Re: Elk Hills Power Project Wastewater Injection Wells

This letter presents comments and issues from the William Lettis & Associates, Inc. (WLA) review of the proposed Elk Hills Power Plant project (EHPP), located on the former Naval Petroleum Reserve No. 1 (NPR-1) in Kern County, California. We have specifically focused our evaluation on geologic issues related to the proposed wastewater injection wells (injection wells) that are proposed for disposal of power plant blowdown water.

Figure 2. Quaternary Geologic Map of the Proposed EHPP Disposal Well Field Area

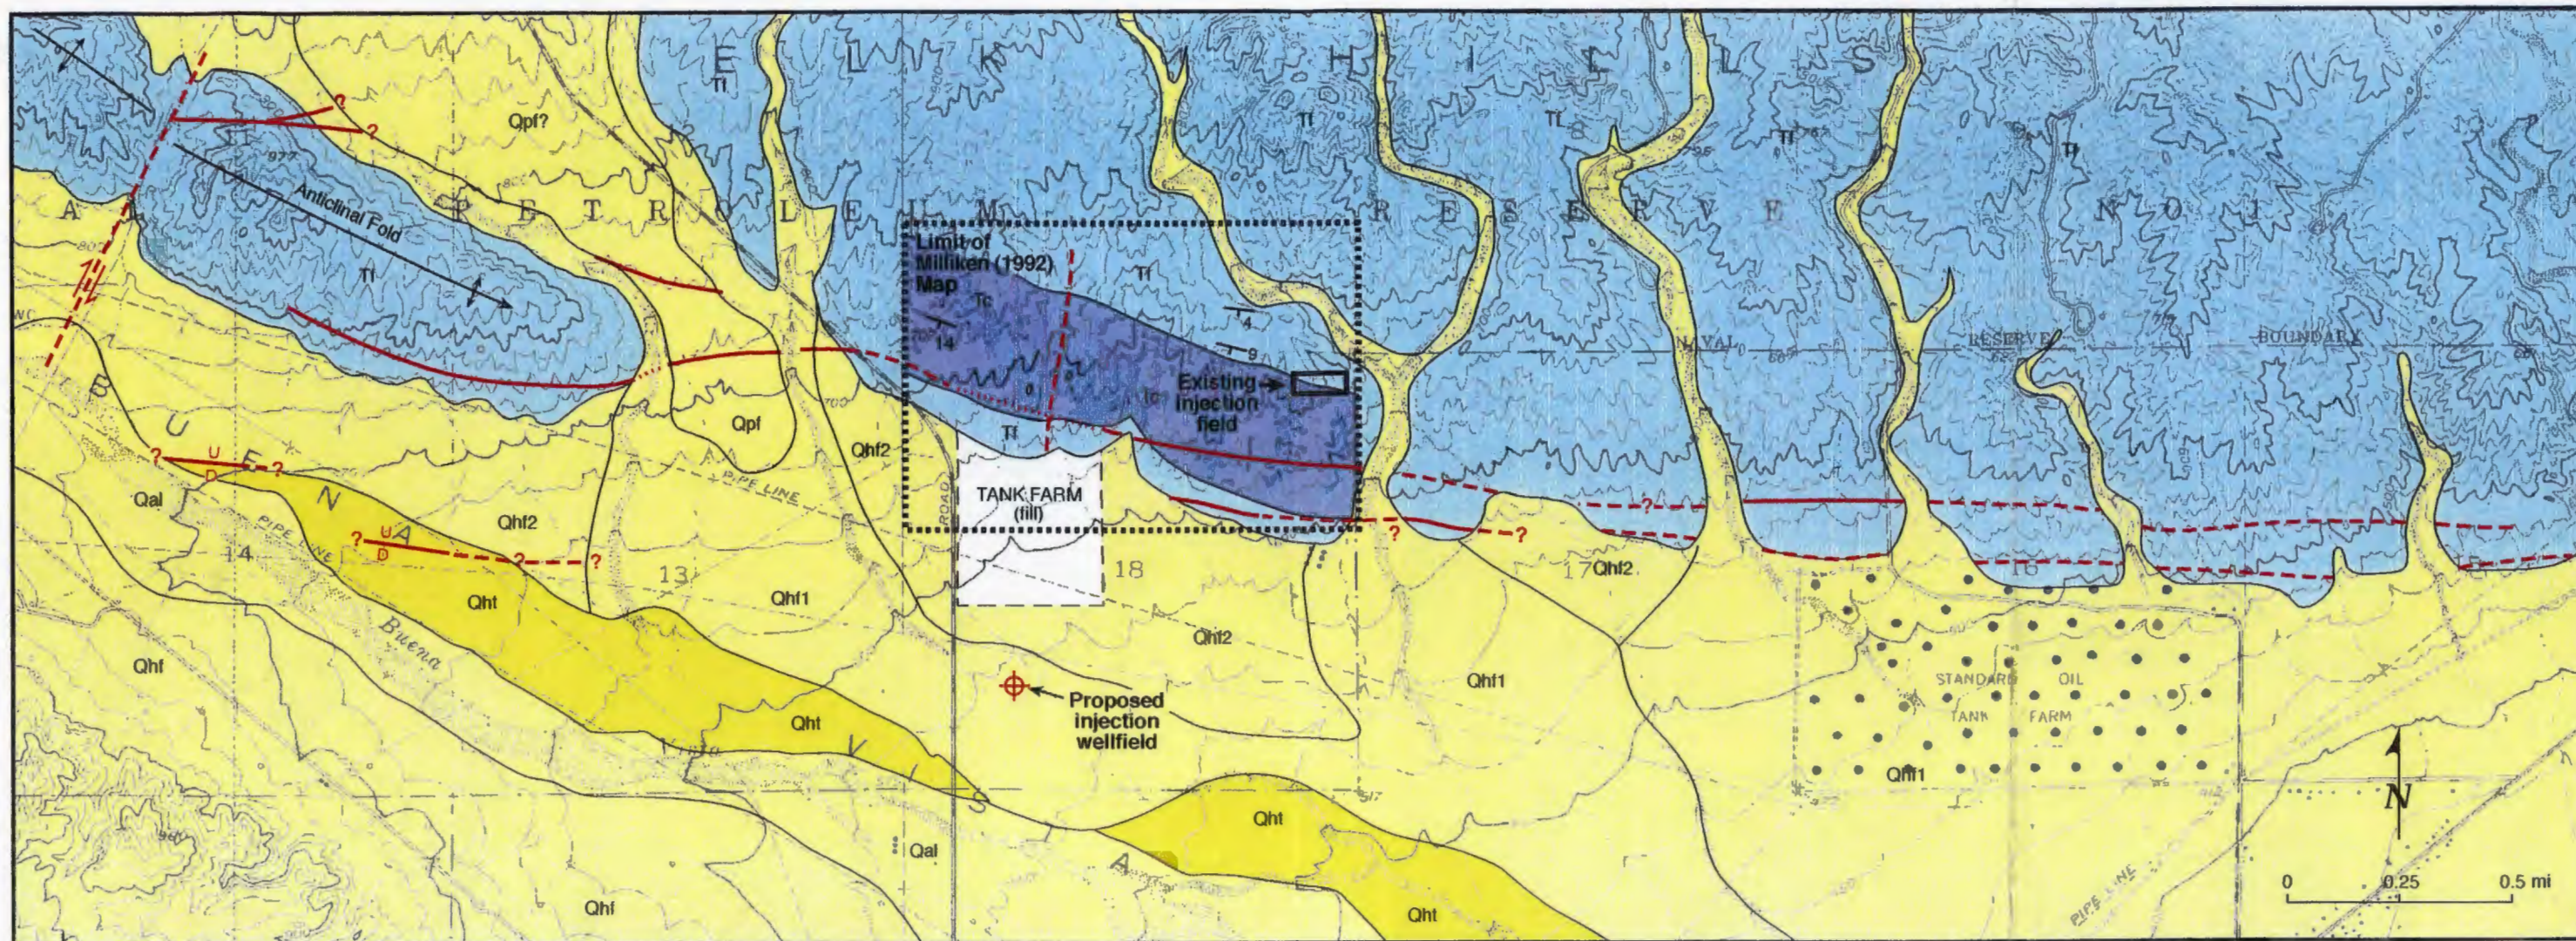
- a. We observed an apparent, east-west trending, continuous (4-mile long) fault in the Tulare Formation and younger alluvial fans (Pleistocene-Holocene) along the base of the Elk Hills immediately north of the EHPP discharge well site (Figures 1 and 2). This apparent fault is not referenced or shown on AFC maps. The apparent fault has a relatively strong geomorphic expression on Tulare Formation and old alluvial fan surfaces, and appears to exhibit measurable strike slip and vertical throw that can be observed in aerial photographs. Drainage swales and bedrock ridges are apparently offset across the fault zone. Milliken (1992), while not recognizing this structure, notes a significant southward steepening of Tulare Formation beds in the vicinity of this fault zone, suggesting a possible correlation between faulting and deformation of the Tulare Formation. The cross section in AFC Figure 5.4-5 shows a distinct inflection or "bend" in the Tulare Clay below the proposed injection well field. Such inflections mark locations of potential stress accumulation, and often delineate areas subject to fracturing or development of faults in response to regional tectonic stress. The apparent fault observed by WLA in aerial photographs appears to be similar to the northwest-trending Tupman fault referenced in Milliken (1993) along the north margin of the Elk Hills. In addition, a series of south-vergent thrust faults are shown in the vicinity of the disposal well site on AFC Figure 5.4-5.

- b. The apparent "south margin" fault should be inspected in the field. If this feature is field-confirmed to be a fault, then additional geologic mapping and borehole evaluation should be performed to determine fault geometry and relationship to the Tulare Clay.

- Potential faults were observed on aerial photographs in the Tulare Clay and older alluvial fan surfaces along the south margin of the Elk Hills just north of the EHPP injection well field. These features should be inspected in the field, and further characterized if confirmed to be faults. Potential fault rupture and earthquake hazard to the injection wells and pipeline should be addressed. Rupture hazard from creep or triggered slip along surface and potential buried (blind) faults in the injection well field area should be addressed.
